## AMENDED APPLICATION

**To:** Village of Enosburg Development Review Board  
**From:** Stephen Diglio, P.E., Project Engineer  
**Re:** AMENDED Project Narrative: NERP Applications for Subdivision and Site Plan Review  
**Date:** October 12, 2020

### **FINDINGS AND DECISION**

Application #SPA-1(A)-20 71 Jay View Drive, Enosburg Falls (AMENDED SITE PLAN)  
Tractor Supply building lot 3 (JV0071)

ASP.2

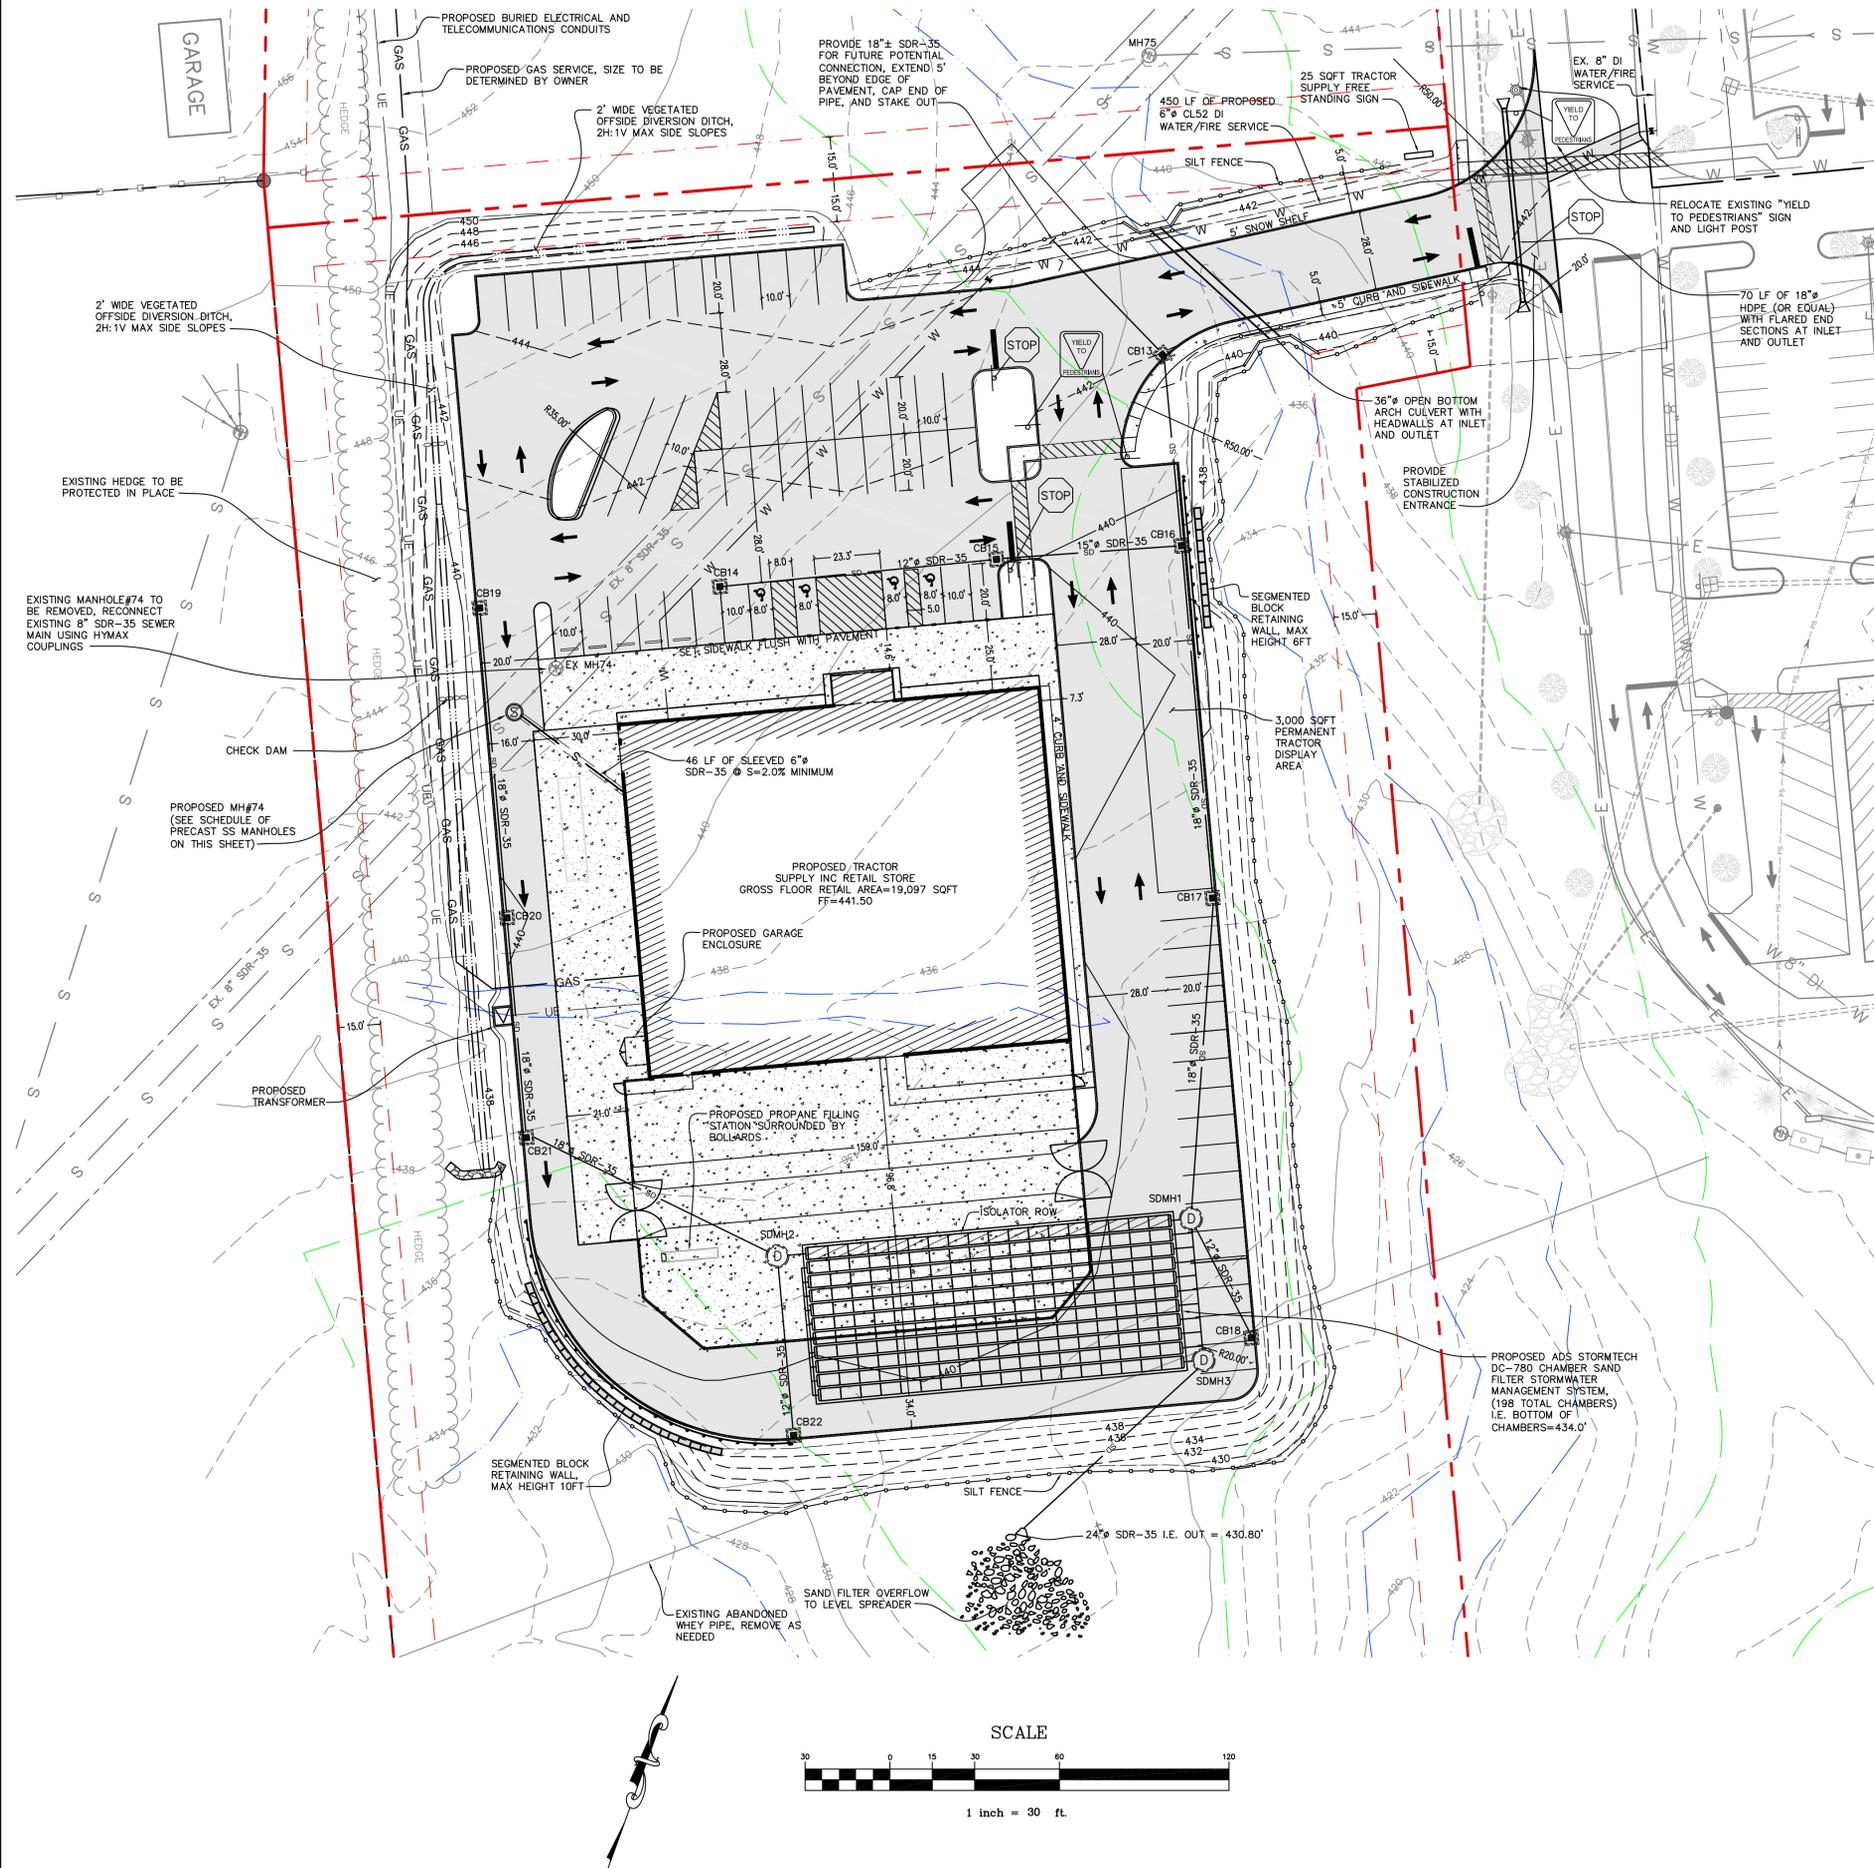
The site plan indicates one proposed tree on the north side of the parking located within the wastewater utility easement; The Village has indicated the location of the tree in the utility easement;

1. Applicant shall provide a revised site plan clearly indicating the ends of Jay View Drive.
2. The applicant shall ensure that no plantings for screening will be located within the utility easement boundaries;
